Date: 29 November 2021

Checklist Comments Report – Response

Project Name: 411 Michigan Ave

HPB Plan Version 2 Corrections Report Response (HPB21-0486)

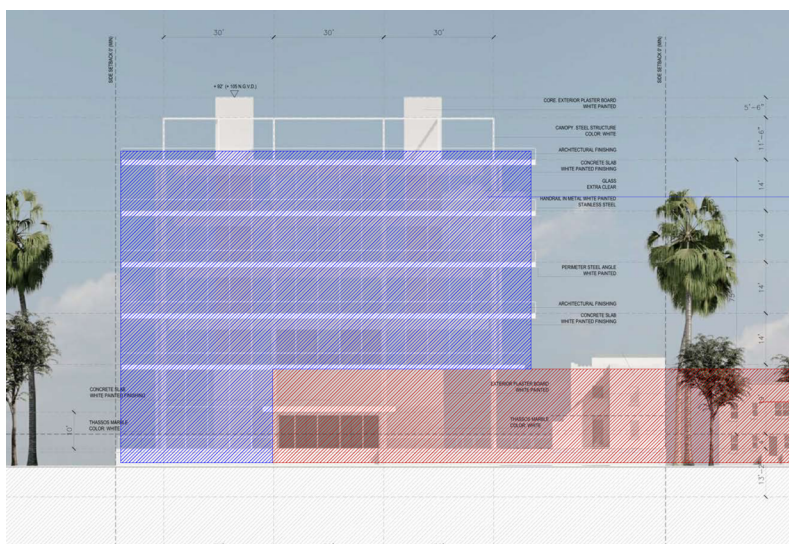
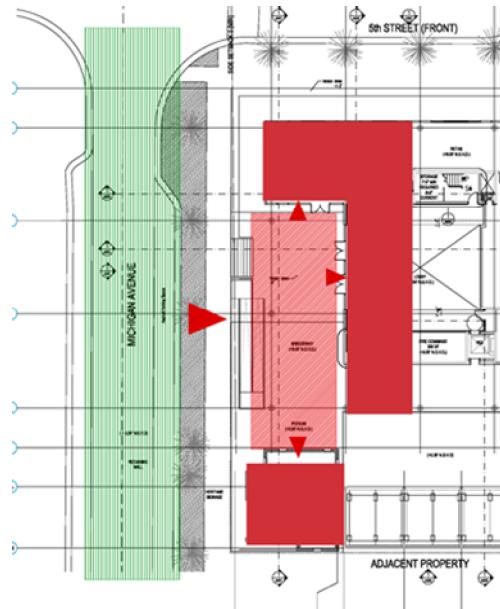
- c. *Provide in narrative and/or visual form, the design inspiration for the designs of the buildings including how they relate to the fabric and architectural heritage the surrounding historic district and greater Miami Beach.*

Please see design architect's narrative on page A6.2. Additionally, the response below:

411 Michigan is a "gateway" building on 5th Street, one of the most prominent vehicular arteries in Miami Beach. 411 Michigan is also placed in a significant historic neighborhood where several key architectural styles from different times converge. In recognizing this unique opportunity, we responded to the site's recognizable position and historical ties by commissioning a master contemporary Architect who's designs profoundly recognize both the past and the future. We established the following principles that each respond to a particular architectural tradition in South Miami Beach: symmetry (Art Deco), activated outdoor space (Mediterranean Revival), and minimalism (MiMo). These principles become the foundation and genesis of our design for 411

Symmetry is an essential characteristic to the Art Deco style. The plan, elevation and sectional diagram of the building are all cleanly and identifiably symmetrical.

Mediterranean Revival features “courtyard[s] and arcades, loggias and porches to provide easy access to the outdoors”. Mediterranean Revival is reflected in this building through the open to the sky courtyard at the 3rd Level, the Entry Plaza, and the large wrapping balconies on every floor.

MiMo’s Design Guidelines reference courtyards and open-air corridors that directly speaks to the contextual plan diagram and demands from climate and use; all of which are elements utilized in our proposal for the new office building at 411 Michigan. MiMo’s Design Guidelines also reference breeze blocks to reference Art Deco, which are the key building element of our stand alone garage behind the historic house. The design of our building coincides within the design guidelines for this neighborhood and the context of South Beach.
